Access Compliance Report Public Rights-of-Way (Pedestrian Signals)

Main Street: **LOS Alamitos Blvd** Cross Street: **ORANGEWOOD AVE** Location: **SW**

ADA ID: **SGRK211217115131** Signal Type: **One Push Button-Non APS** Overall Compliance: **No** Severity Scores: **BTN 1: 10** **BTN 2: N/A** **No BTN: N/A**

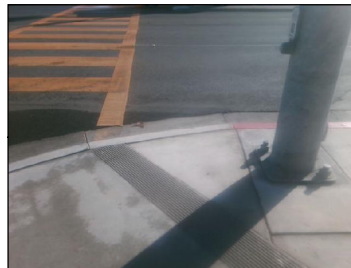
N/A Is Button 1 APS or Non-APS?	NonAPS	N/A Is Button 2 APS or Non-APS?	N/A
N/A B 1 VibroTact Arrow?	N/A	N/A B 2 VibroTact Arrow?	N/A
N/A B 1 VibroTact Parallel to Xing?	N/A	N/A B 2 VibroTact Parallel to Xing?	N/A
N/A B 1 VibroTact Contrast	N/A	N/A B 2 VibroTact Contrast	N/A
No B 1 Pilot Light?	No	N/A B 2 Pilot Light?	N/A
N/A B 1 Pilot Light Illumination?	N/A	N/A B 2 Pilot Light Illumination?	N/A
N/A B 1 Walk Indicator Type	N/A	N/A B 2 Walk Indicator Type	N/A
N/A B 1 Walk Indicator Audible?	N/A	N/A B 2 Walk Indicator Audible?	N/A
N/A B 1 Locator Tone?	N/A	N/A B 2 Locator Tone?	N/A
N/A B 1 Tone Audible Range?	N/A	N/A B 2 Tone Audible Range?	N/A
B 1 Addl APS Features?	No	B 2 Addl APS Features?	N/A
B 1 Addl APS Features Notes	N/A	B 2 Addl APS Features Notes	N/A

Possible Solutions: Replace Signal Push Button With APS Button.
